**SUNDRY NOTICES AND REPORTS ON WELLS**  
*Do not use this form for proposals to drill or to re-enter an abandoned well. Use Form 3160-3 (APD) for such proposals.*

8. Well Name and No.  
BRADLEY-FEDERAL #5

9. API Well No.  
30-015-00382

**Permanent Abandonment of Federal Wells  
Conditions of Approval**

~~spot 25~~  
~~spot 25~~ Bradley Federal #5

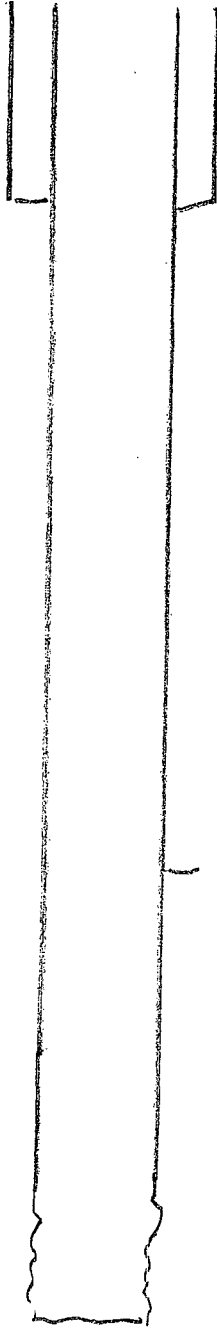
perforated & sg 45 SK  
@ 500' - Surf  
in/out 7" cgs.

perforated & sg 25 SK  
@ 1025-975

TOC 1,323 calc  
spot 25 SK @ 1625-1525

spot 25 SK @ ~~1435-1835~~ TO 185/  
7' @ 1935' w/ ~~125~~ 75 SK ✓
